SUBJECT: DRAFT SAFETY EVALUATION REPORT SUPPLEMENT NO. 2 FOR THE
RIVER BEND STATION UNIT 1

SUBJECT: DRAFT SAFETY EVALUATION REPORT SUPPLEMENT NO. 2 FOR THE
RIVER BEND STATION UNIT 1

River Bend Nuclear Plant

Figure 2.1 Location of G-tunnel (River Bend Station)

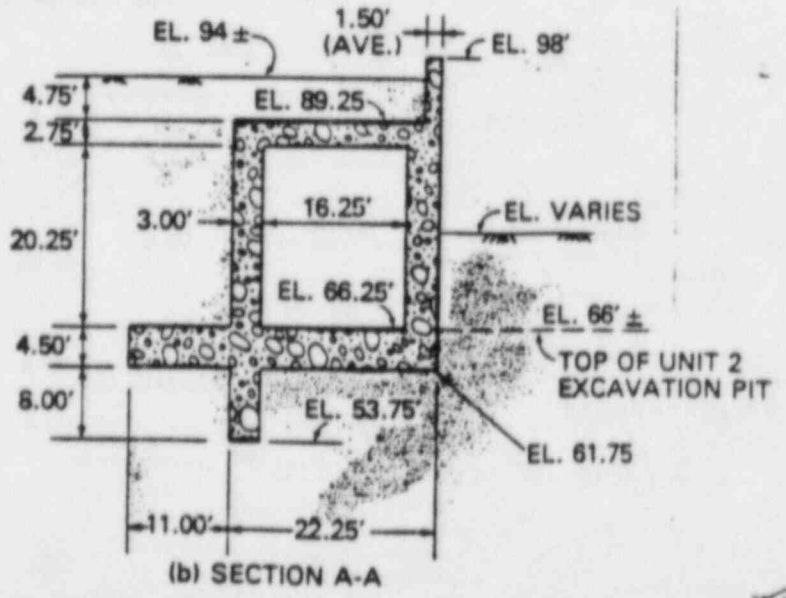
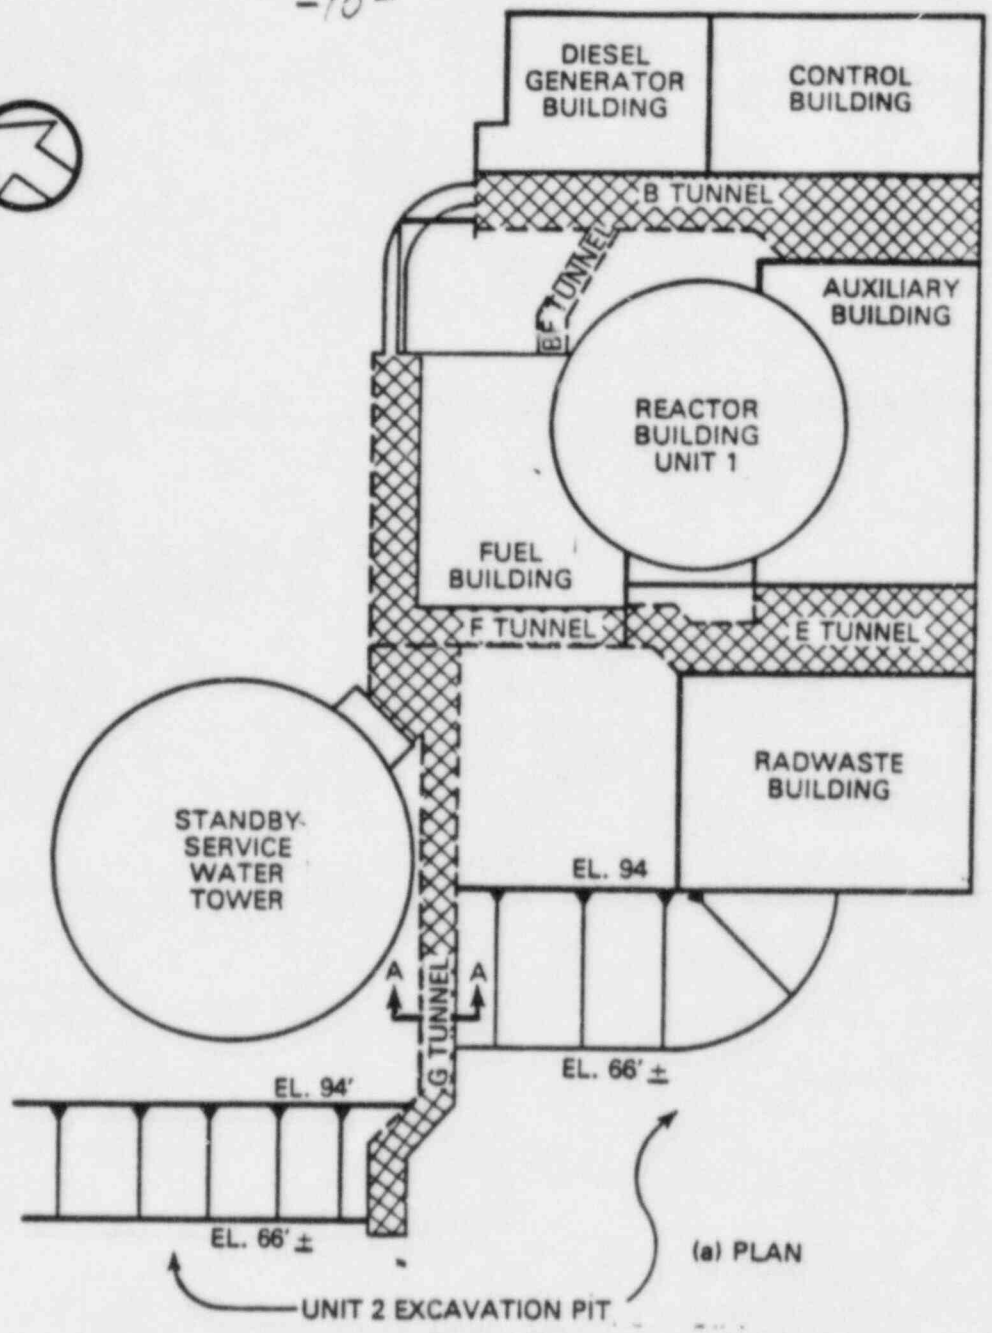
Figure 2.1 of this SER shows a plan and cross-section of the service water tunnel (G-tunnel). This tunnel starts from the F-tunnel at the west end of the Unit 1 fuel building, runs past the Unit 1 standby service water tower, and terminates near the Unit 2 fuel building. The G-tunnel is a reinforced concrete box-type structure that was originally intended to be completely buried underground. However, it was decided to cancel Unit 2 and not to backfill the excavation pit above el ±66 ft. Therefore, the G-tunnel remains partly buried at its west end with the backfill on the north side of the tunnel 28 ft higher than that on the south side as seen in Figure 2.1. Unbalanced soil loading on the G-tunnel results from the applicant's decision not to completely backfill around it. Thus, the applicant has performed a stability analysis of the G-tunnel using the following assumptions:

Figure 6.4 (Revised), Loss-of-coolant accident chronology (design-basis accident)

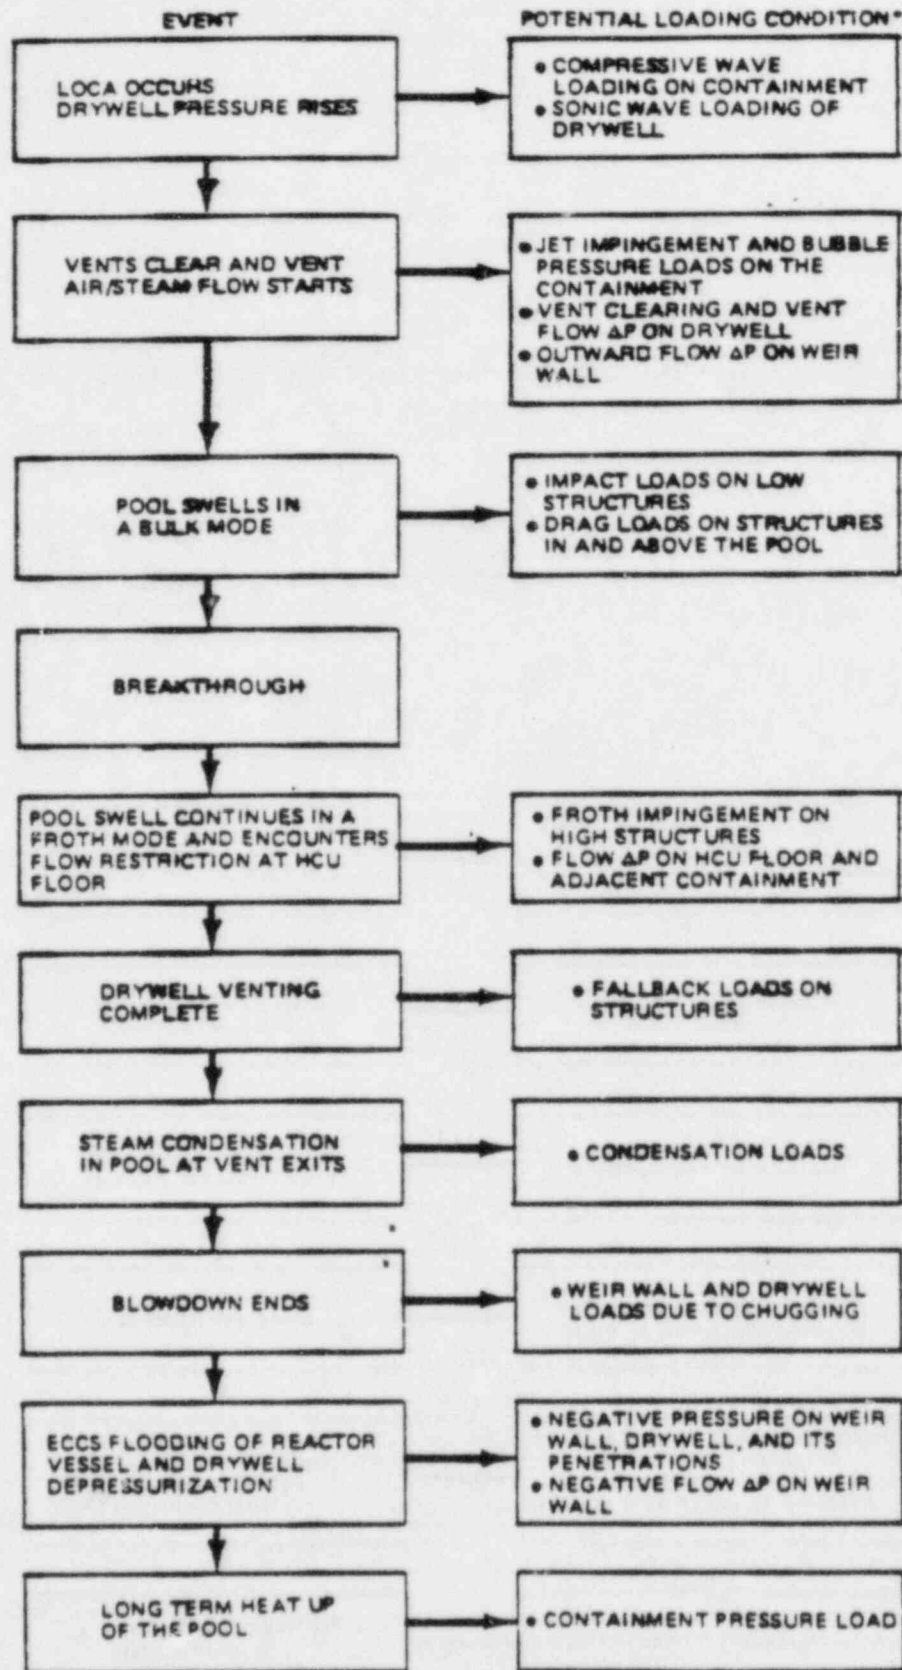
Figure 6.4 of the SER shows the sequence of events occurring during a design-basis accident (DBA) and the potential loading conditions associated with these events. Following onset of a postulated LOCA, the drywell pressure increases because of blowdown of the reactor system. Pressurization of the drywell causes the water initially standing in the vent system to be accelerated into the pool and the vents are cleared of water. During this vent-clearing process, the water leaving the horizontal vents forms jets in the suppression pool and causes water jet impingement loads on the structures within the suppression pool and on the containment wall opposite the vents. During the vent-clearing transient, the drywell is subjected to a pressure differential and the weir wall experiences a vent-clearing reaction force.
